PROJECT: Dexter Community Schools
New Fieldhouse Addition

RE: ADDENDUM 2

Date	March 18, 2026
Project Name	Dexter Community Schools – Dexter High School New Field House
TMP Project No(s).	25026E
Design Release No.	Two (2)
Addendum No.	One (1)

DRAWING NO.
S4.2

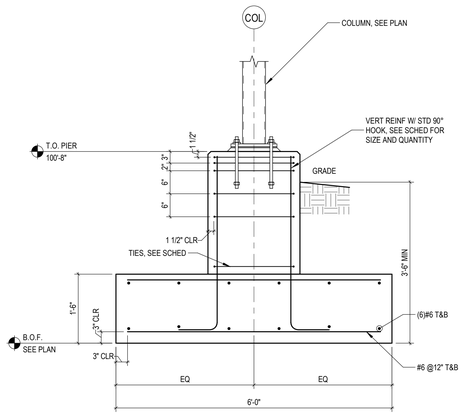
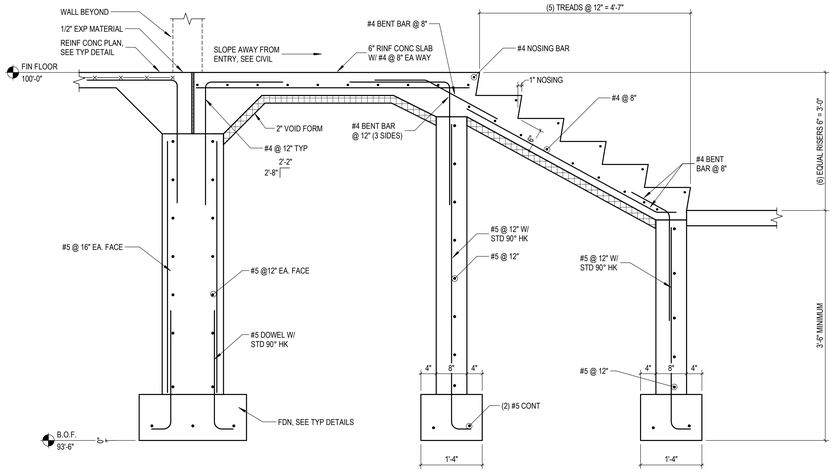
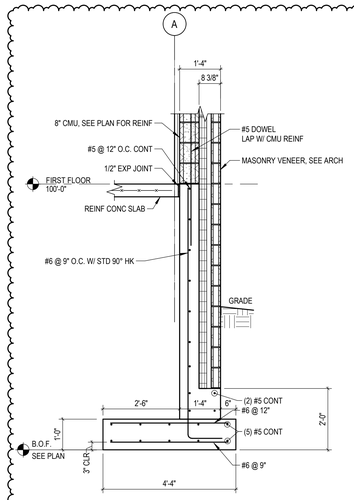
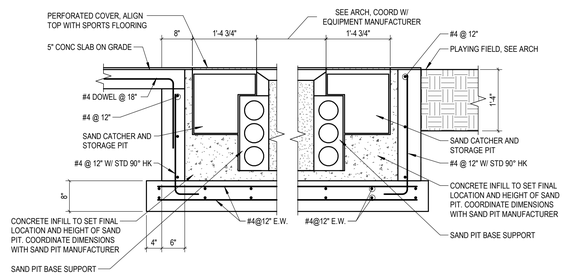
Item No.	**Structural Drawing Changes**
SD-1	Refer to Drawing No. S1.0A (reissued): A. Deleted Detail cut 1/S4.2 as indicated. B. Added Detail cut 11/S4.2 as indicated. C. Revised footing elevations as indicated. D. Revised stoop slab sizes as indicated
SD-2	Refer to Drawing No. S1.0B (reissued): A. Revised Detail cut 12/S4.1 as indicated. B. Added retaining wall as indicated. C. Added Detail cut 10/S4.2 as indicated. D. Added 12/S4.2 as indicated. E. Revised pole vault note as indicated.
SD-3	Refer to Drawing No. S1.2A (reissued): A. Added Detail cut 12/S6.1 as indicated. B. Added C8 framing at Volleyball sleeves as indicated. C. Revised Detail cut 7/S6.1 direction as indicated. D. Revised canopy framing dimensions as indicated.
SD-4	Refer to Drawing No. S4.2 (reissued): A. Refer to Detail 9. Revised top course to 12” CMU as indicated. Revised brick ledge dimension as indicated. B. Added Details 10, 11, and 12 as indicated.

DRAWING NO.
S6.1

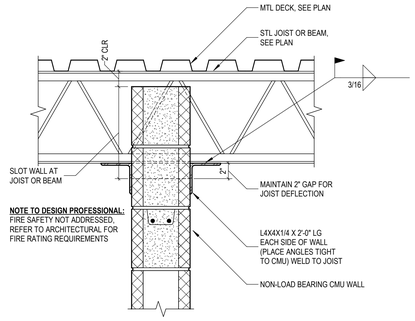
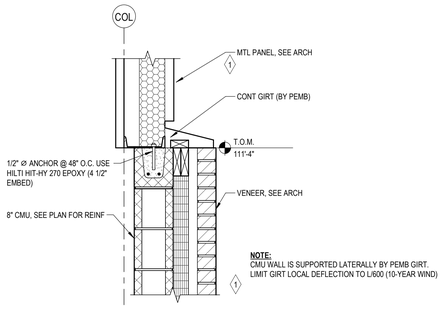
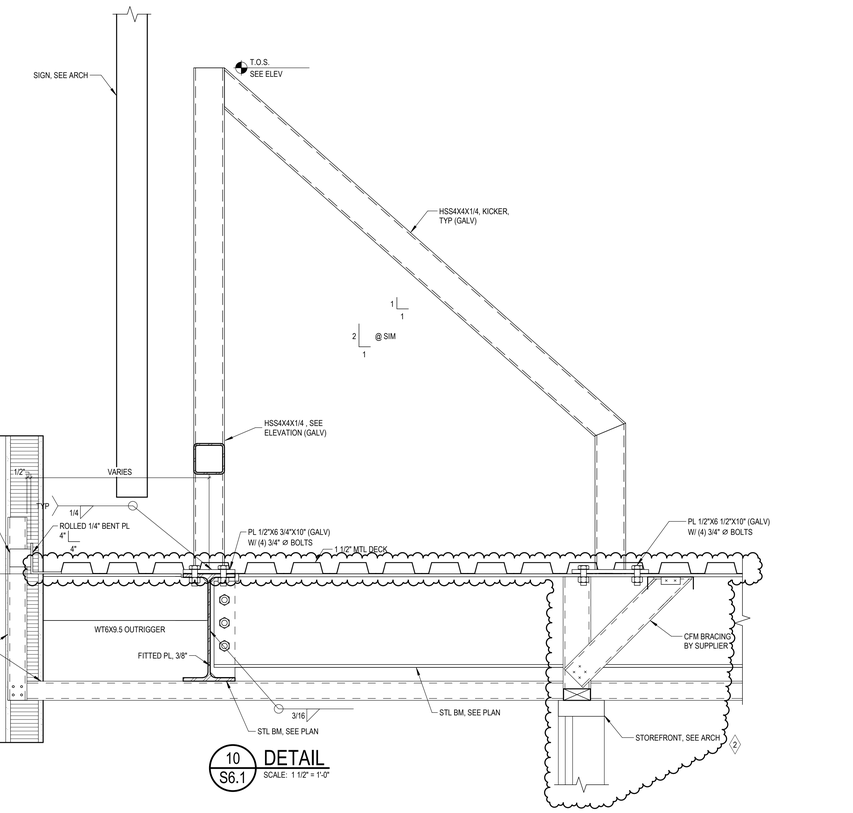
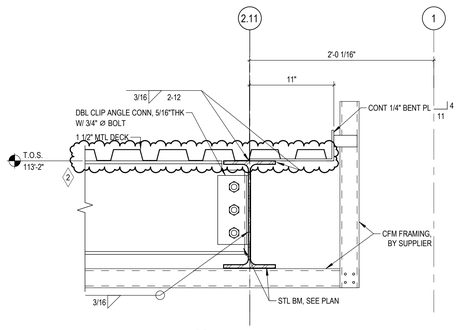
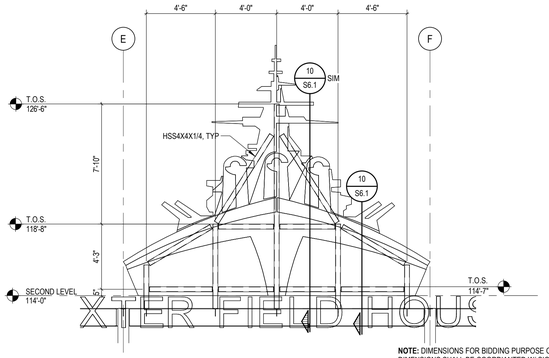
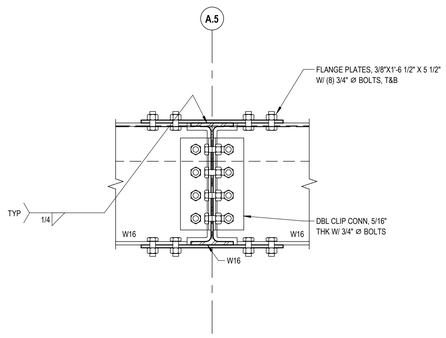
SD-5	Refer to Drawing No. S6.1 (reissued): A. Deleted Detail 3/S6.1 as indicated. B. Refer to Details 8 and 9, revised deck direction as indicated. C. Revised Details 7 and 9 as indicated.

AD.1

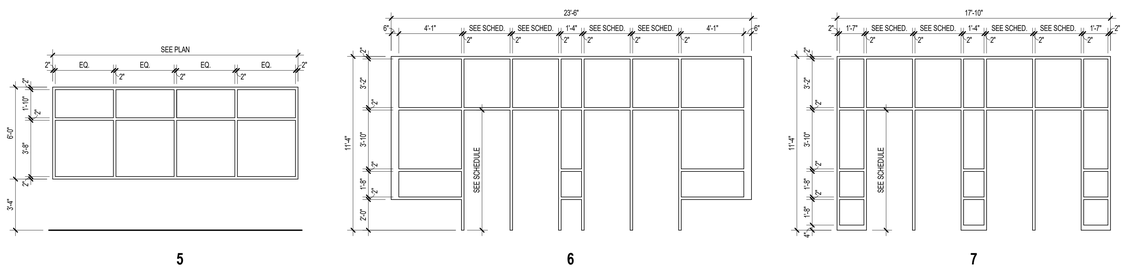
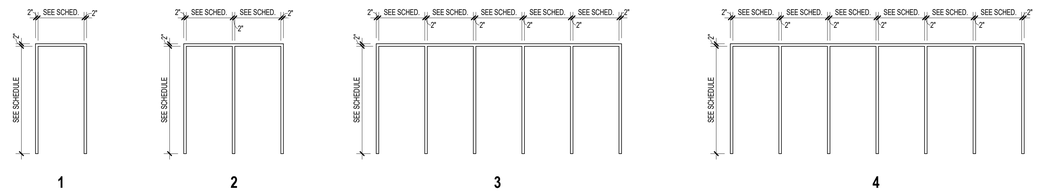
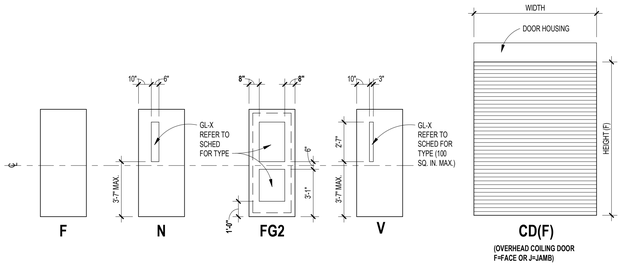
Item No.	Architectural Drawing Changes
AD-1	Refer to Drawing No. AD.1 (reissued): A. Revised door hardware sets as indicated.
AD-2	Refer to Drawing No. A1.2A (reissued): A. Revised volleyball pole sleeves in concrete from 3'' to 4'' diameter as indicated.
AD-3	Refer to Drawing No. A7.2 (reissued): A. Refer to elevation 2, added note to align banners and light fixtures as indicated.
AD-4	Refer to Drawing No. A9.1A, A9.1B, A9.2A, and A9.2B (reissued): A. Removed Projection Screen Schedule as indicated.
AD-5	Refer to Drawing No. A9.3 (reissued): A. Added Dreadnought Logo Floor Plan as indicated. B. Added Dexter Logo Floor Plan as indicated. C. Added general notes as indicated.
AD-6	Refer to Drawing No. A10.1A (reissued): A. Revised flooring at A119 to RSF2B as indicated. B. Revised specific note for flooring at A117 as indicated.
AD-7	Refer to Drawing No. A10.2A (reissued): A. Added game lines at A201, as indicated. B. Revised specific note for flooring at 202 as indicated.

DRAWING NO.
E3.1A

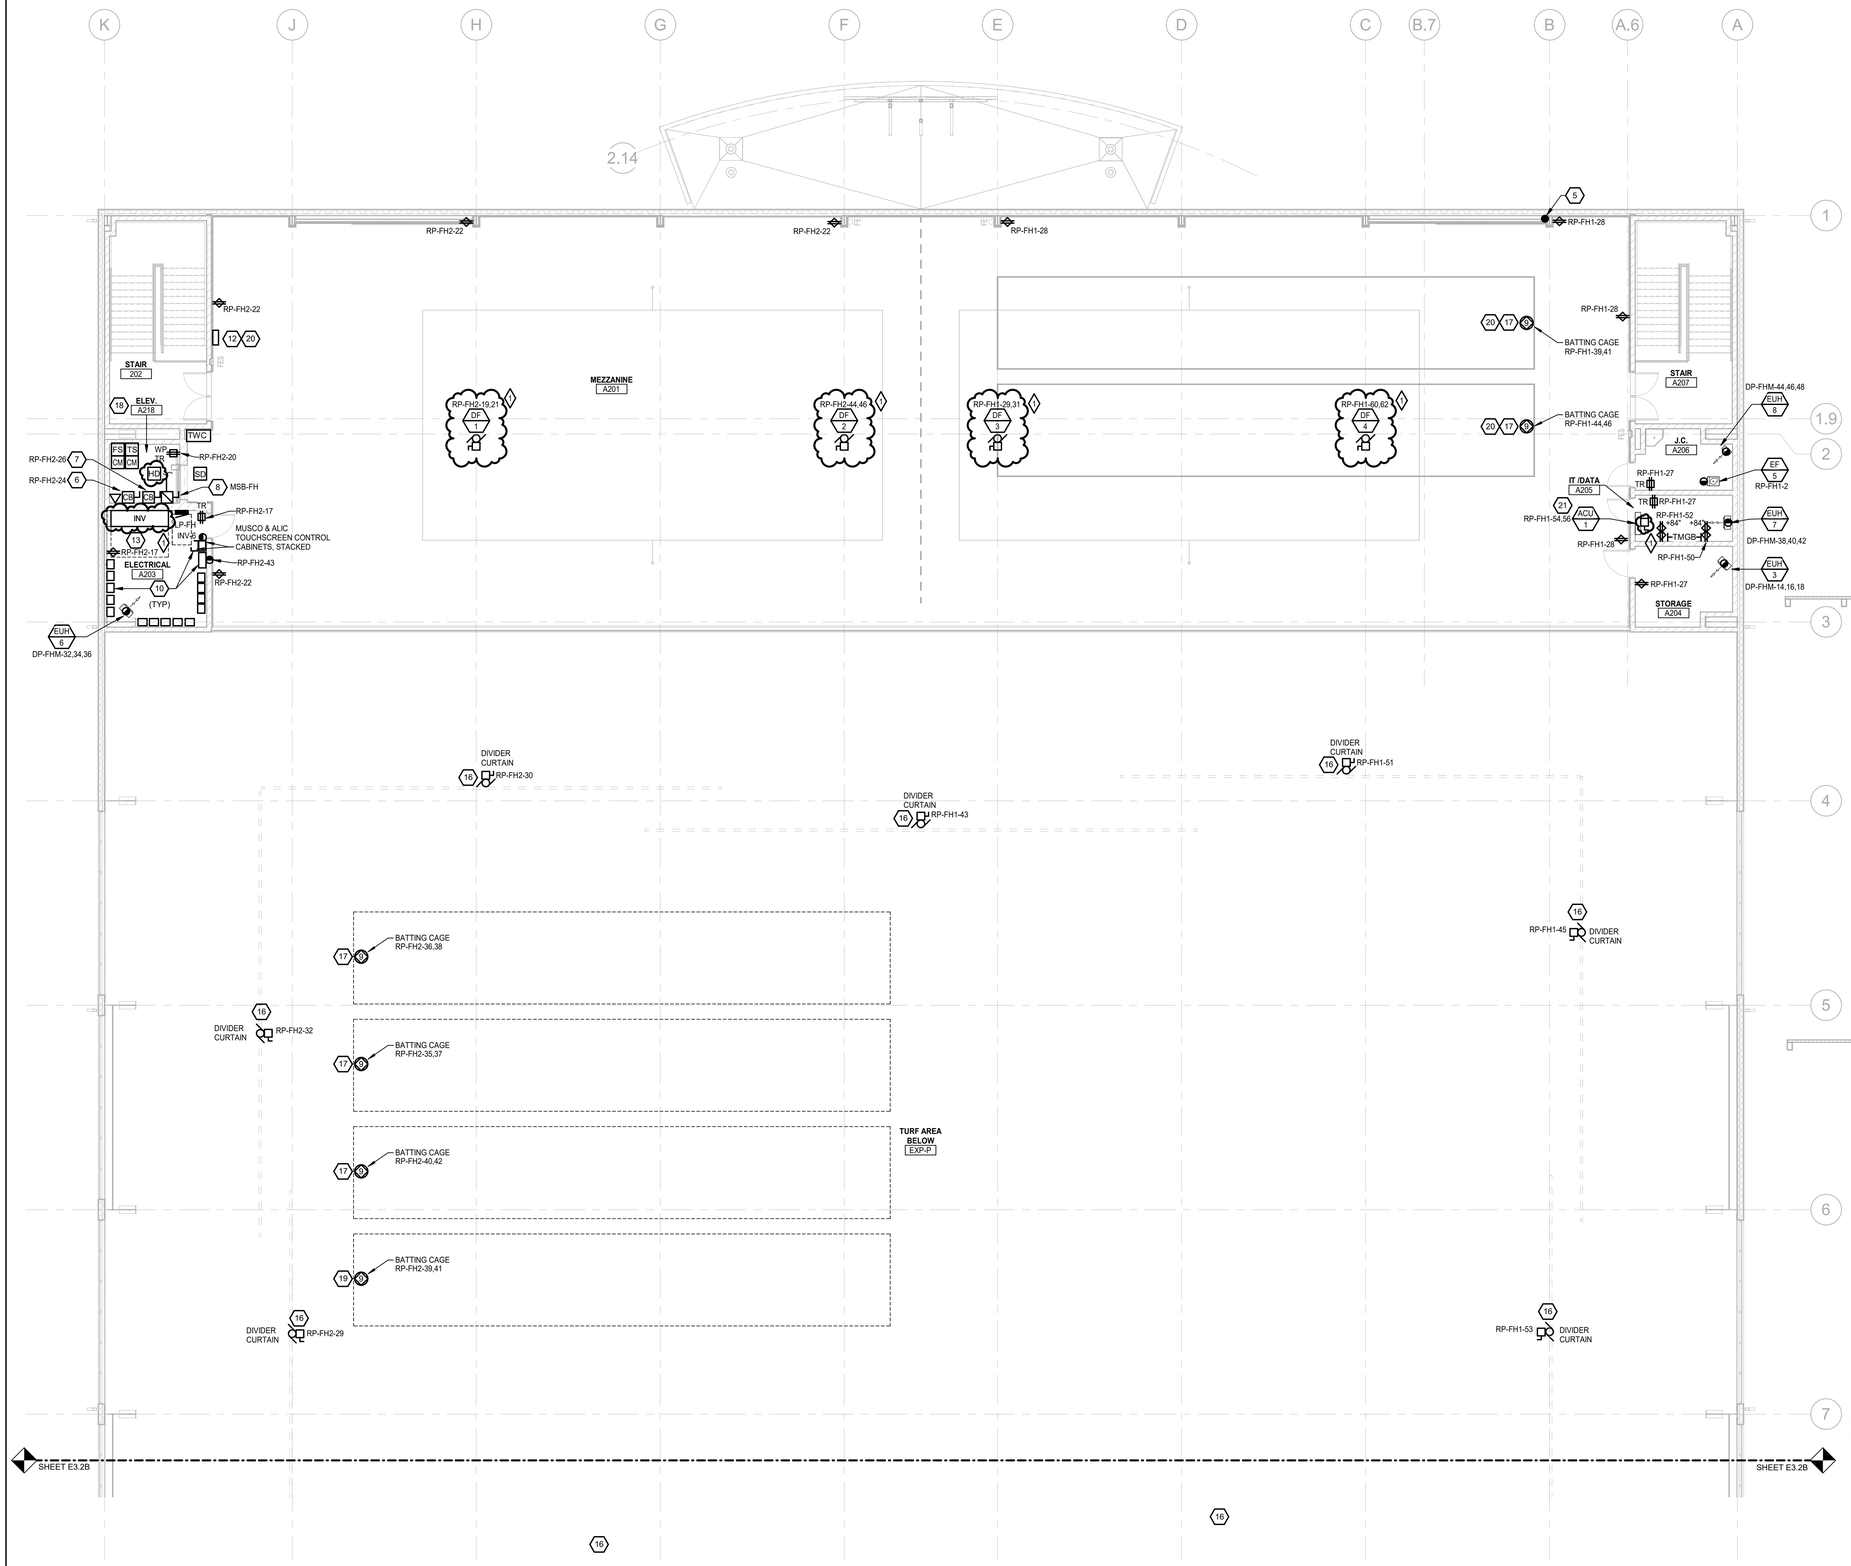
Item No.	**Electrical Drawing Changes**
ED-1	Refer to Drawing No. E2.1A (reissued): A. Added mounting height note for light fixture type L10 in the lobby. B. Designated one L1 fixture in the passage as a night light/emergency fixture. C. Indicated fixture label and circuit designation at 2x4 light fixture at the toilet entrance.
ED-2	Refer to Drawing No. E2.2A (reissued): A. Added exit sign to the west stair entrance. B. Added construction note 8 at fixture type L11 in the elevator hoistway as indicated. C. Revised circuiting for the EBU in the electrical room as indicated.
ED-3	Refer to Drawing No. E3.1A (reissued): A. Added circuit numbers for the future hand dryers in toilet rooms as indicated. B. Revised TWCP location and associated power connection as indicated. C. Indicated location of turf equipment controller in J.C. A120.
ED-4	Refer to Drawing No. E3.2A (reissued): A. Revised inverter footprint in electrical room. B. Revised key notes 2, 5, 17 and 19 as indicated. C. Revised hardwired connection for ACU-1 to a non-fused disconnect switch. D. Revised DF-1 thru DF-4 circuiting as indicated & revised receptacle to non-fused disconnect. E. Revised smoke detector to heat detector in elevator hoiseway.

2 TC101 TYPICAL CABLE LABELING AT FACEPLATE & PATCH PANEL

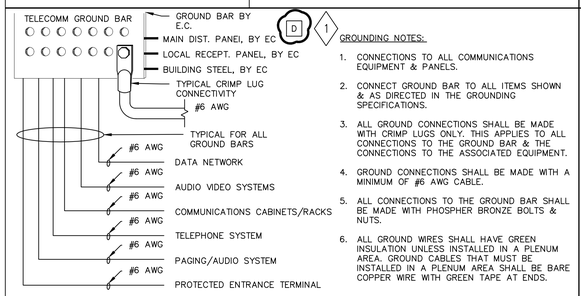
Item No.	**Technology Drawing Changes**
TD-1	Refer to Drawing No. TC101 (reissued): A. Updated schedule and detail with correct info as indicated.

TC302

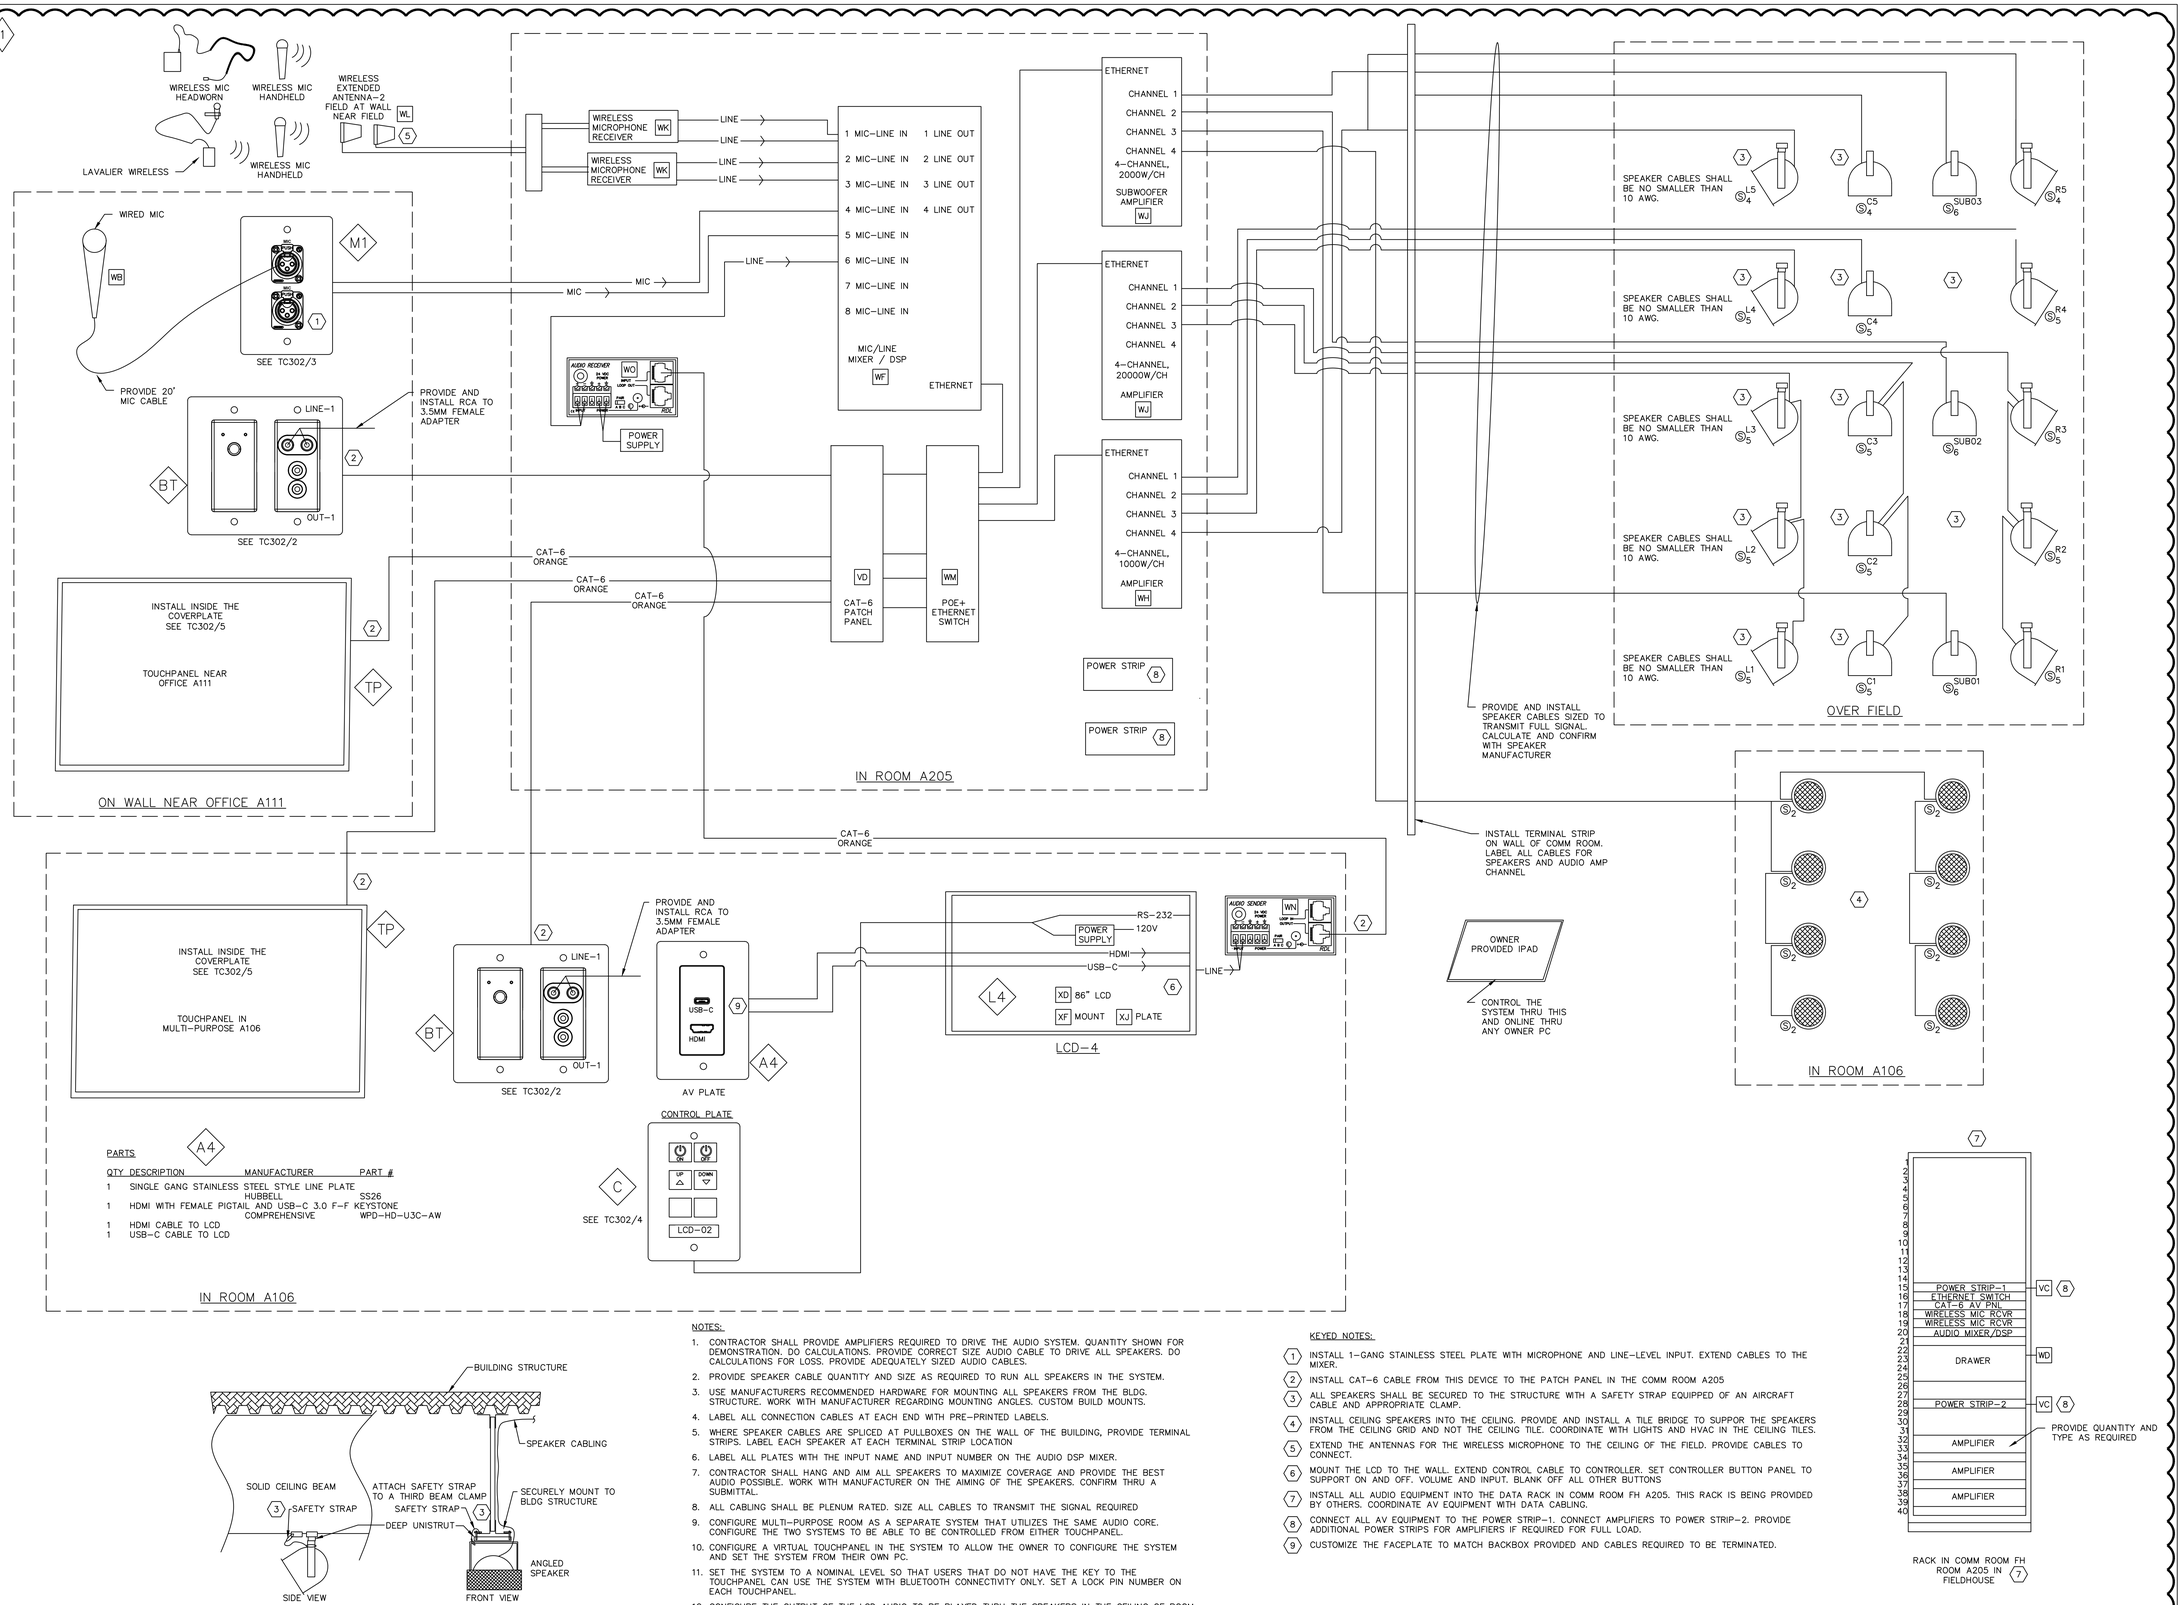
TD-5 Refer to Drawing No. TC302 (reissued):
A. Updated details with correct info as indicated.
